## Development Permit Panel

1. **DEVELOPMENT PERMIT 16-735007**  
(REDMS No. 5611727)

APPLICANT: Alex Sartori  
PROPERTY LOCATION: 6020 No. 4 Road

2. **DEVELOPMENT PERMIT 17-774155**  
(REDMS No. 5660408)

| Sheet Name | SITE PLAN |

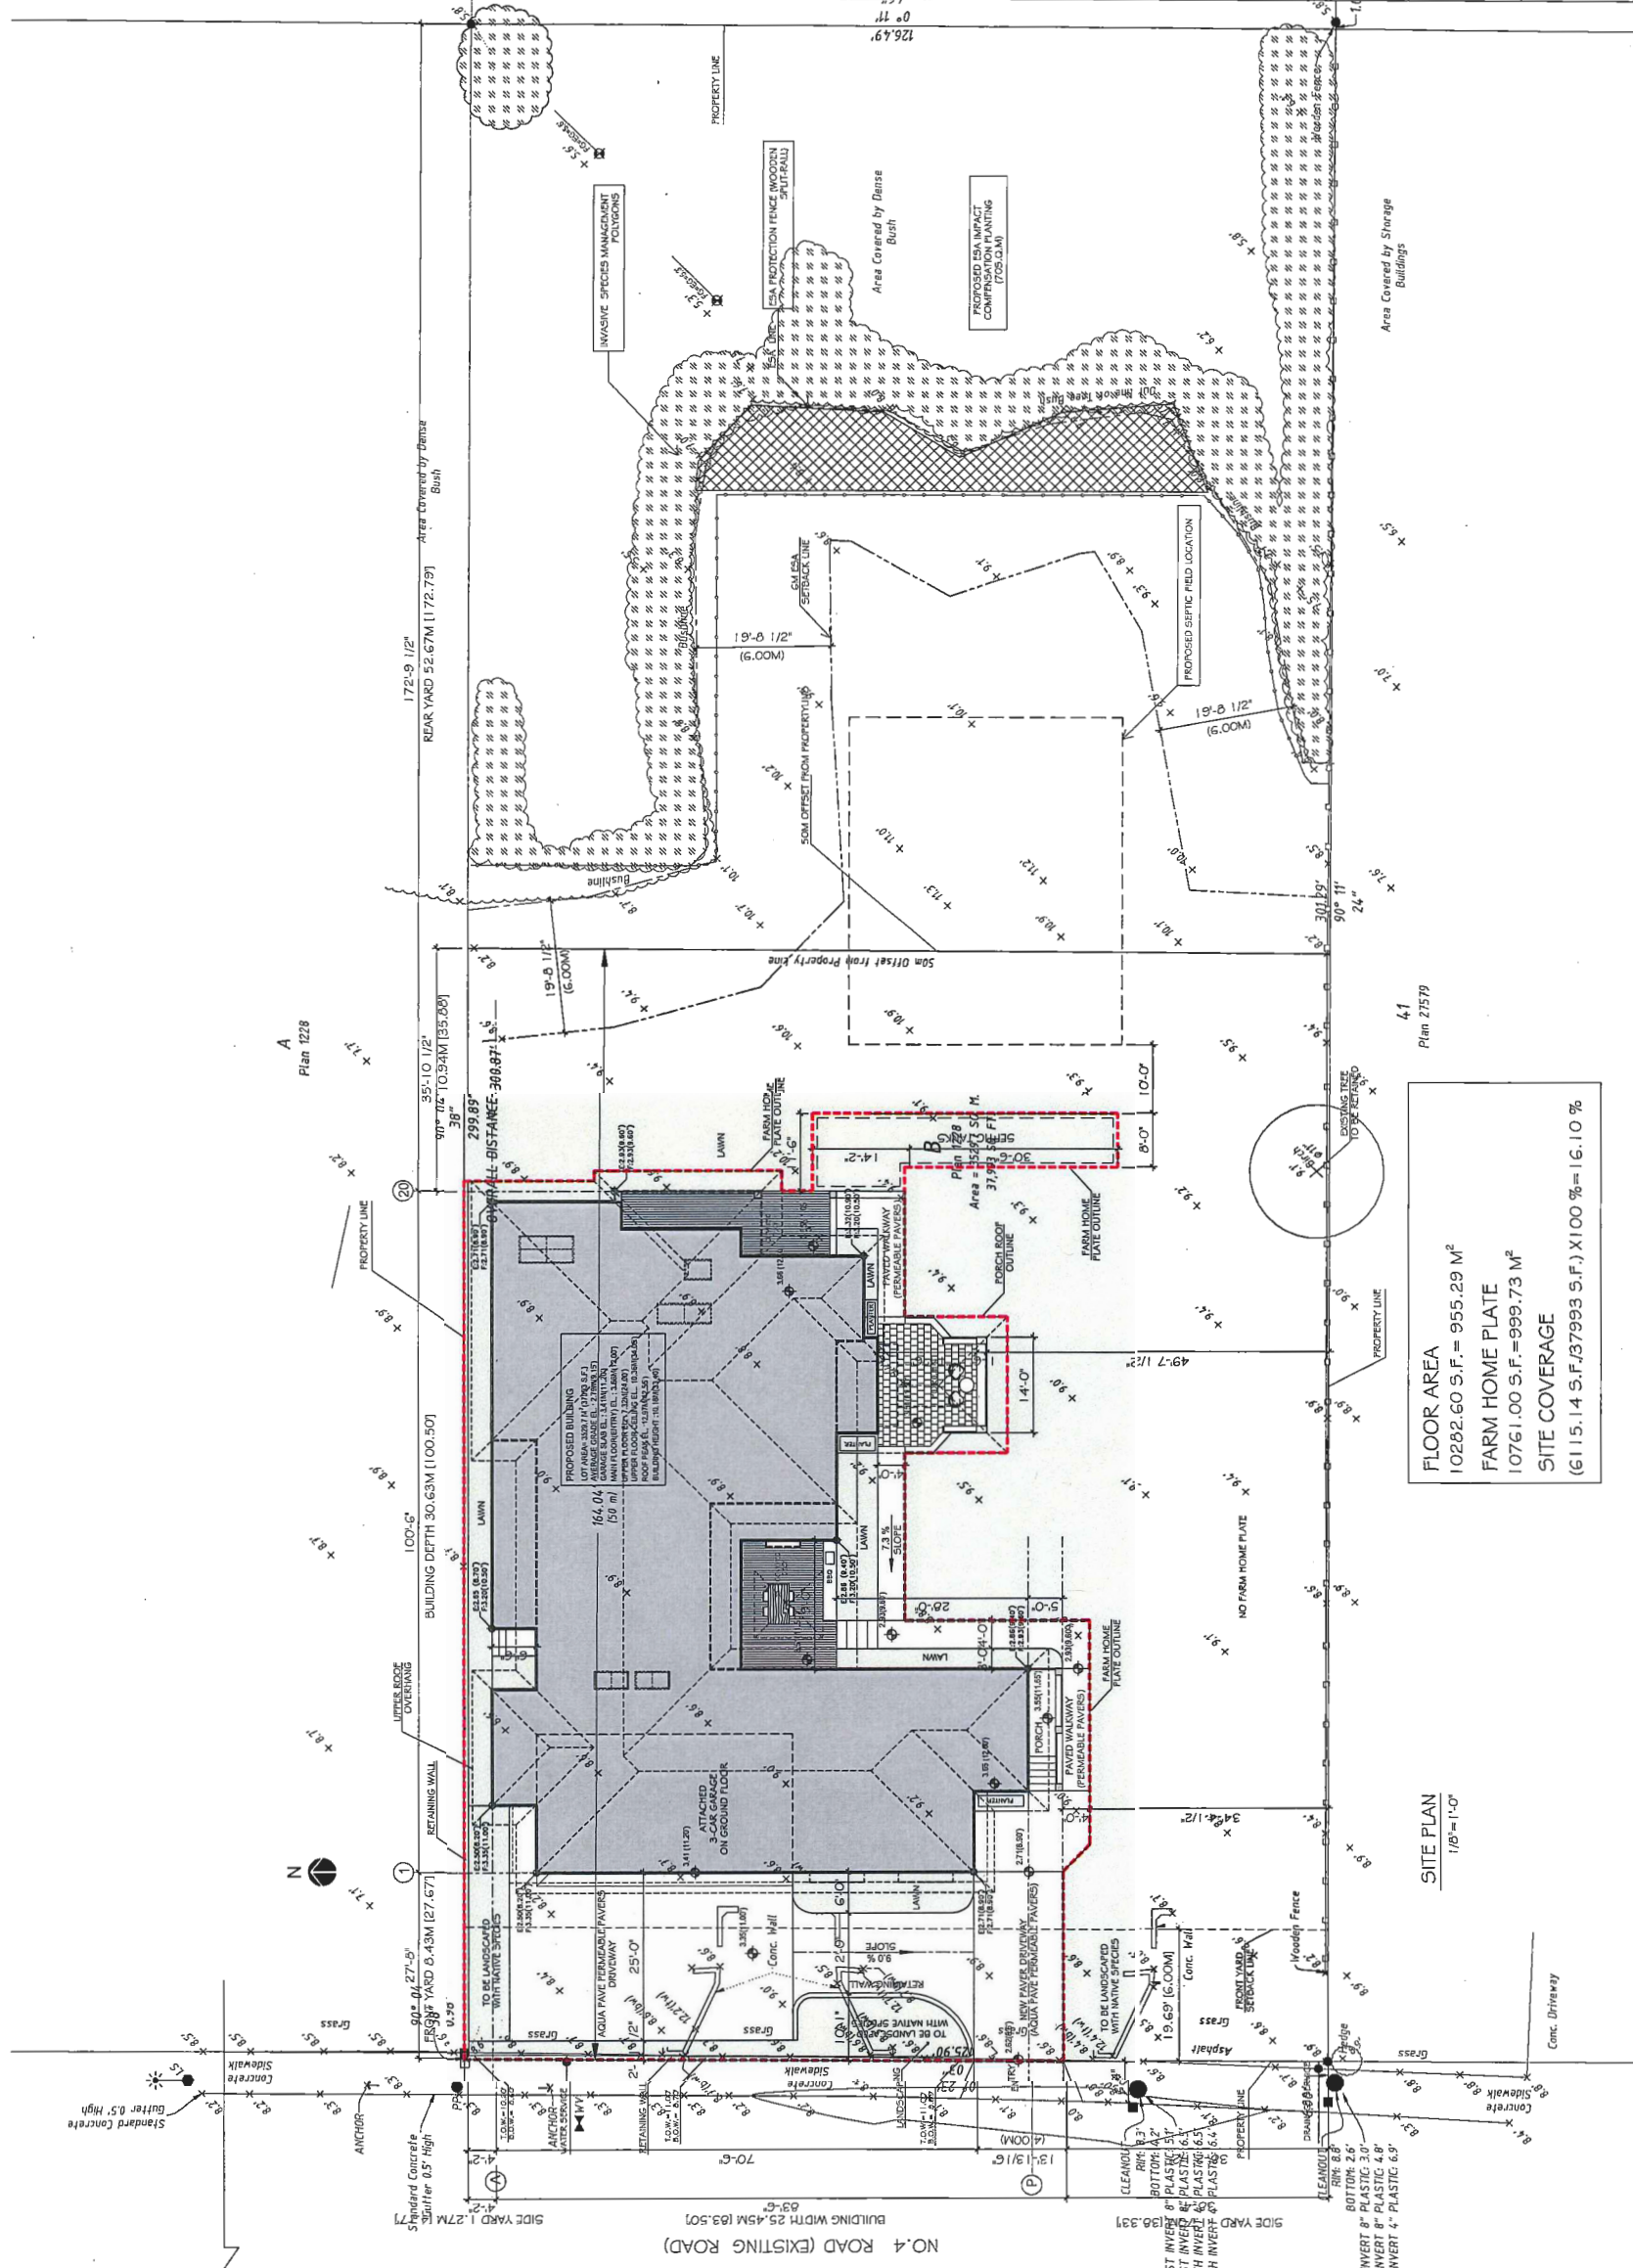
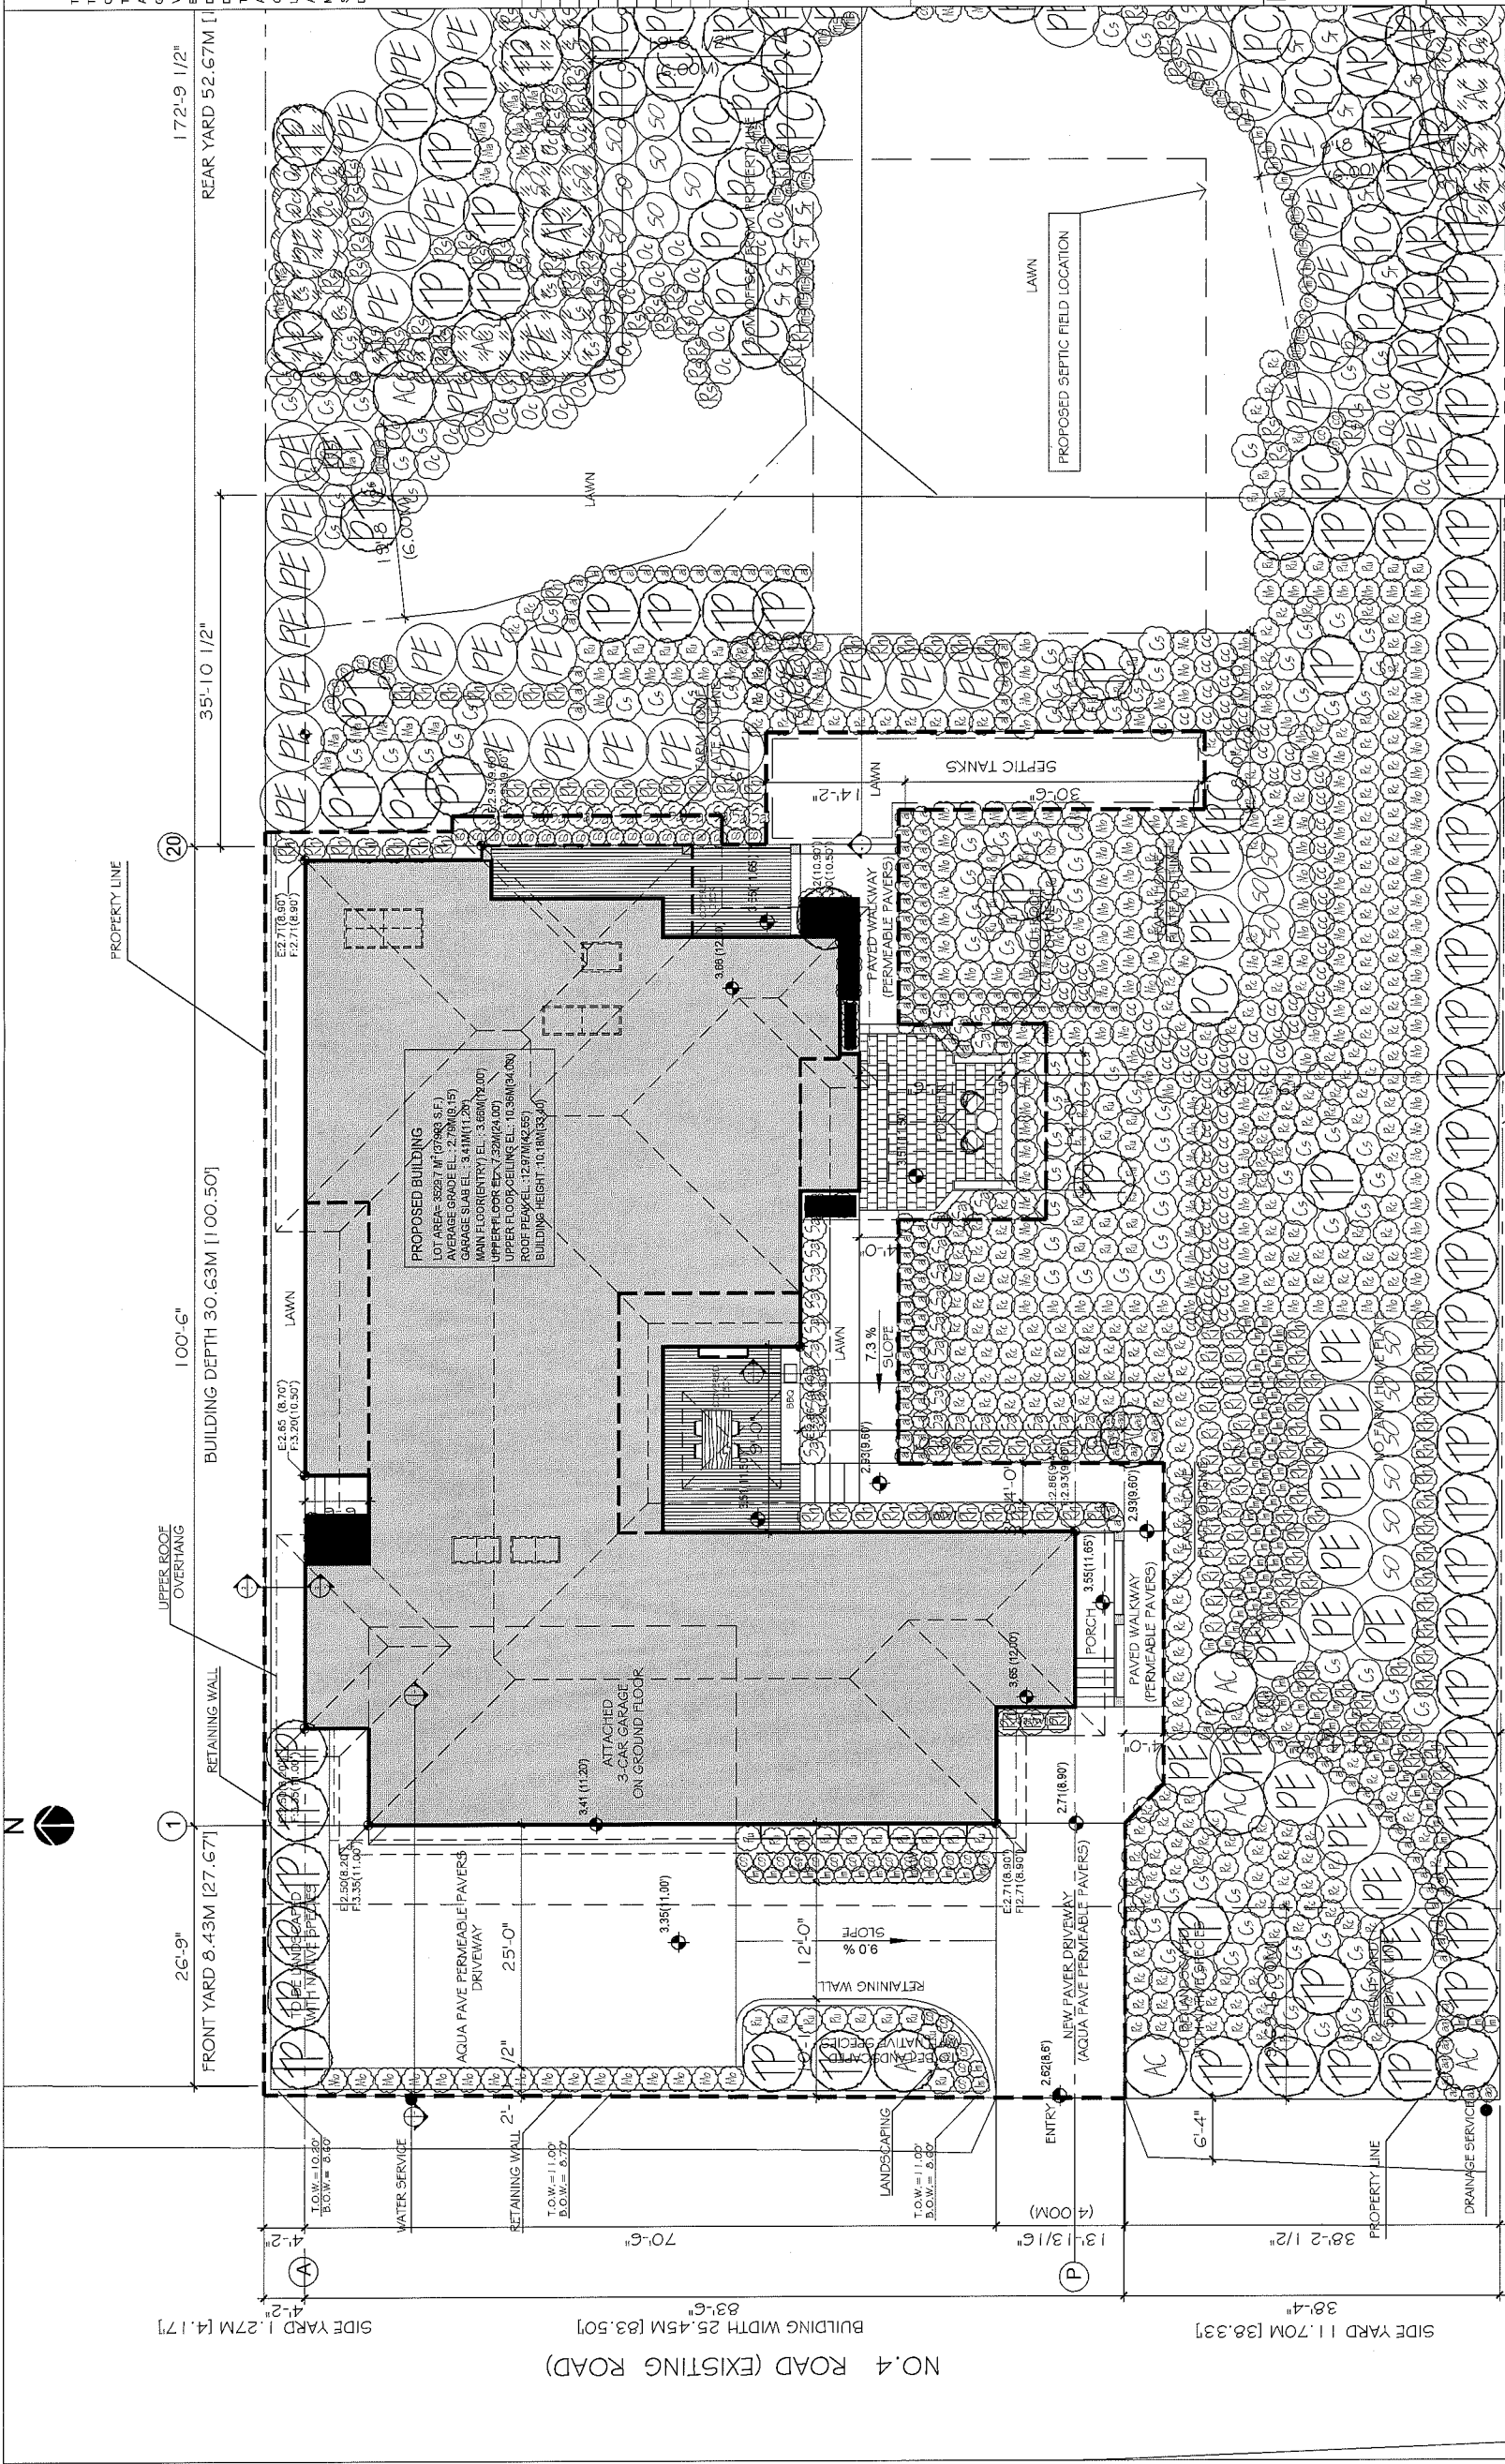
Panel Comment: ***Consider redesigning the proposed development to minimize its encroachment into the ESA.***

Response: The proponents have reduced the size of the house from 1,067.21 m<sup>2</sup> (11,487.35 ft.<sup>2</sup>) to 999.35 m<sup>2</sup> (10,656.9 ft.<sup>2</sup>) and eliminated the driveway which was previously planned along the south side of the house. That southern driveway is proposed to be replaced by additional ESA landscaping. In addition, all the structures previously located overtop of the septic field have been removed and replaced with grass.

1 ROOF PLAN  
SCALE 1/8"

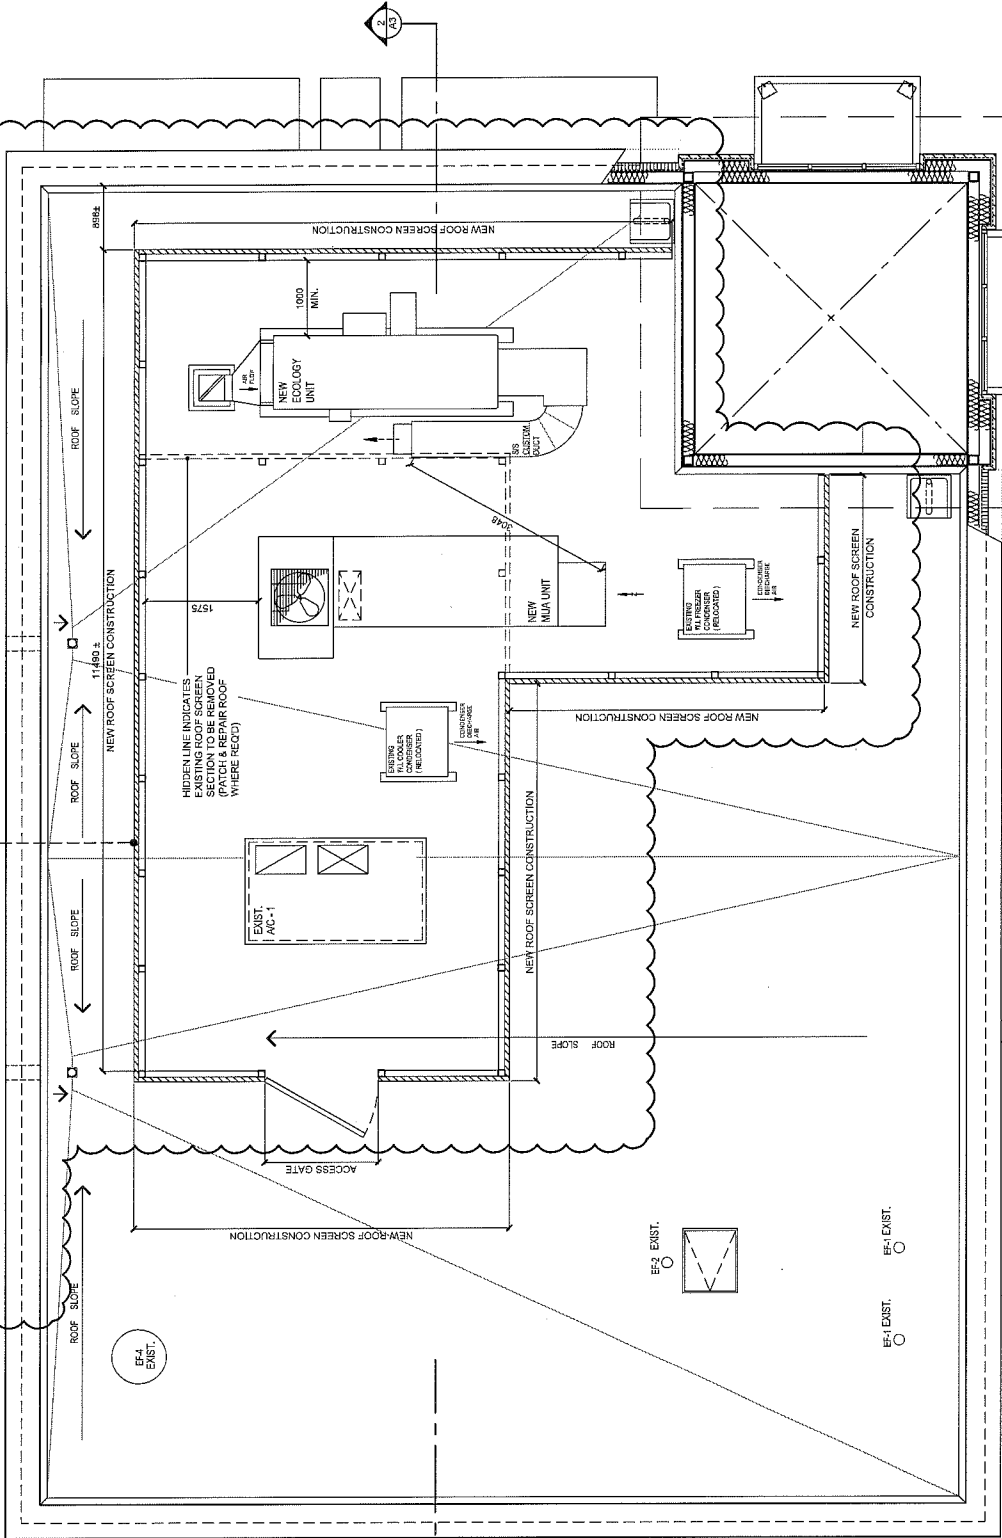
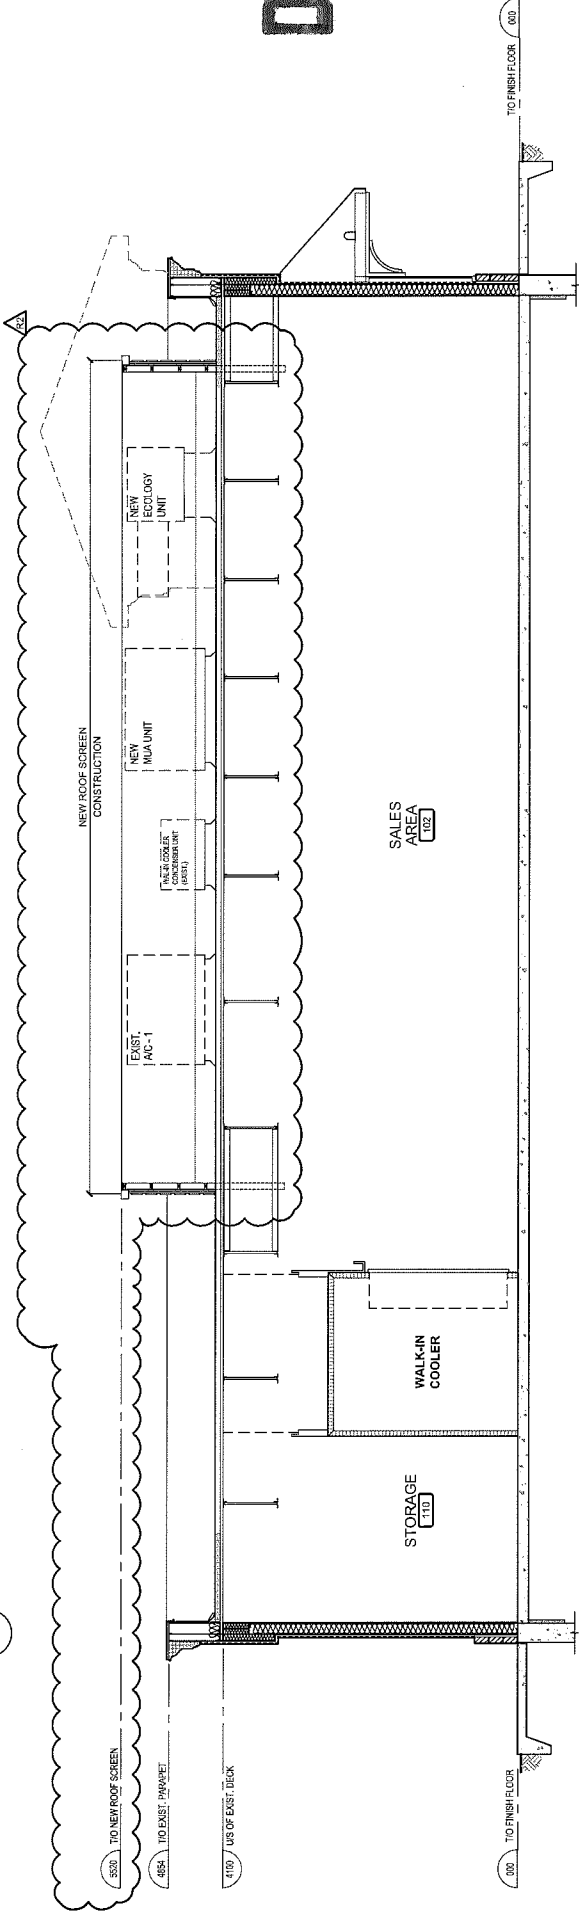
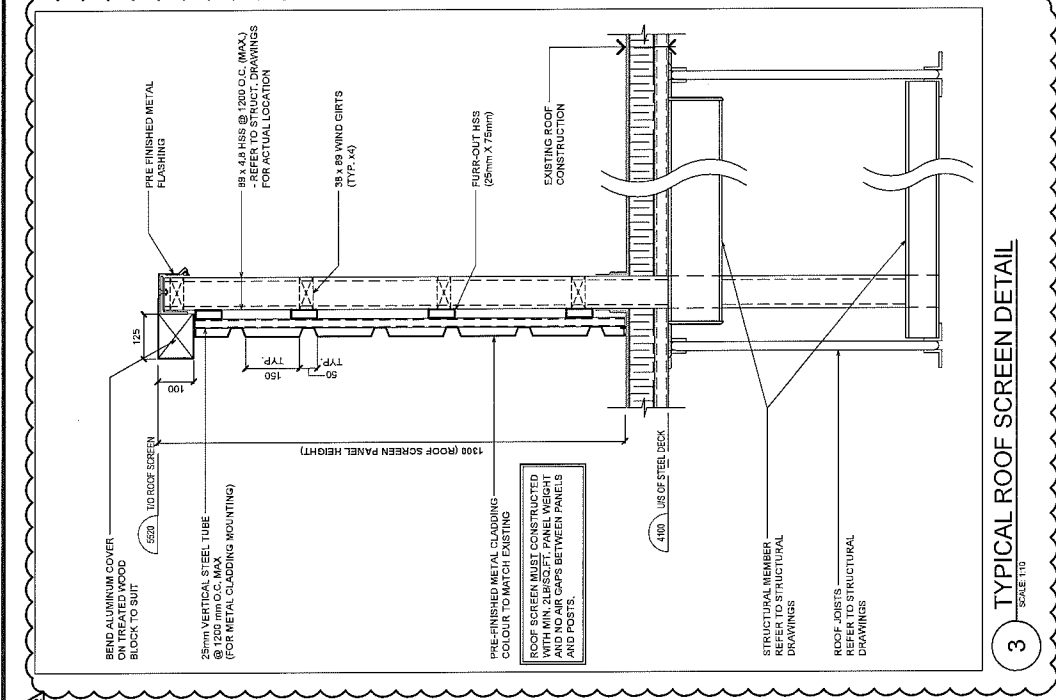
In reply to a query from the Panel, Ms. Stilwell acknowledged that an extra piece of mechanical equipment will be installed and the applicant's acoustical consultant had advised that the height of the existing rooftop screen be increased to comply with the City's Noise Regulation Bylaw.

In reply to queries from the Panel, Mr. Craig advised that (i) the applicant could provide an updated building elevation showing the approximately two feet increase in height of the rooftop screening for mechanical equipment, (ii) after the staff report on the subject development application had been published, staff received information from the applicant regarding the proposed increase in the height of rooftop screening, (iii) staff noted that the height increase complies with the Zoning Bylaw and consistent with existing materials on the building as conveyed by the applicant, and (iv) increasing the height of the rooftop screening is one of the options to address the installation of additional mechanical equipment on the rooftop.

NEW ROOF SCREEN (TYPICAL)  
MUST BE CONSTRUCTED WITH MIN. 2 LB/SD.FT. PANEL WEIGHT  
AND NO AIR GAPS BETWEEN PANELS AND POSTS.  
PROVIDE ALL NEW ROOF SCREEN TO MEET ABOVE REQUIREMENTS IF NEEDED.
